**From:** [Yu, Olivia, EMNRD](#)  
**To:** ["Grubbs, Richard T"](#)  
**Cc:** [Mark Larson; Tucker, Shelly](#)  
**Subject:** RE: Chevron 1RP-4715 and 1RP-4818  
**Date:** Monday, January 8, 2018 9:21:00 AM  
**Attachments:** image001.png

**From:** Grubbs, Richard T [mailto:rtgrubbs@chevron.com]  
**Sent:** Wednesday, January 3, 2018 9:28 AM  
**To:** Yu, Olivia, EMNRD <Olivia.Yu@state.nm.us>  
**Cc:** Mark Larson <Mark@laenvironmental.com>; Tucker, Shelly <stucker@blm.gov>  
**Subject:** Chevron 1RP-4715 and 1RP-4818

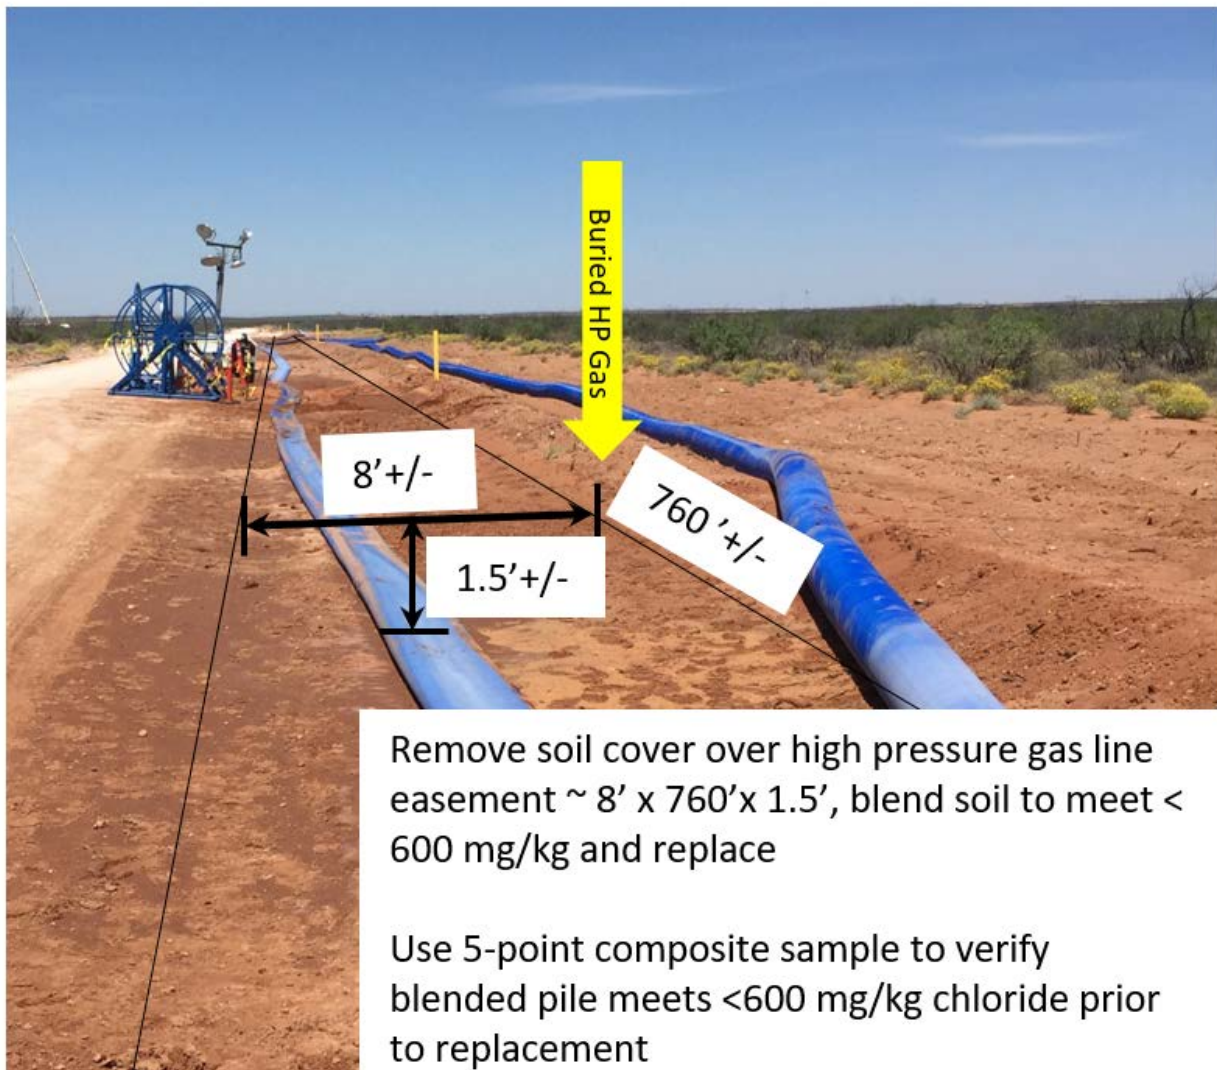
- Due to the concern with excavation along and over this high pressure gas line, Chevron requests the option to remove the top layer of soil already disturbed in this easement, to the depth of 1 to 1.5-foot of soil, blend the soil, and replace it along the length and width of the impacted area (approximately 760-foot from east end near S-1 to the west end near S-4, and approximately 8-foot wide). Prior to replacement, a 5-point composite sample of blended soil would be completed to verify that blended soil is  $<600$  mg/kg. Imported top soil would be used, as required, to achieve  $<600$  mg/kg chloride. (see the diagram below)

- On the south side of the Soil  $> 600$ mg/kg in the location of S-7 will be removed and replaced with imported fill.

NMOCD approves of the proposed additional delineation for 1RP-4715 with these stipulations:

1. Blended soil must be tested every 50 cubic yards for chlorides using EPA Method 300.
2. Based on the data provided from the delineation report dated from July 18, 2017, permissible level of chloride is not obtained until 4-5 ft. bgs for the area represented by S-7. Laboratory analyses of discrete confirmation bottom and sidewall samples are required for at least 2 sample locations.
3. Imported soil must demonstrate chloride levels  $\leq 600$  mg/kg and with similar soil characteristics.
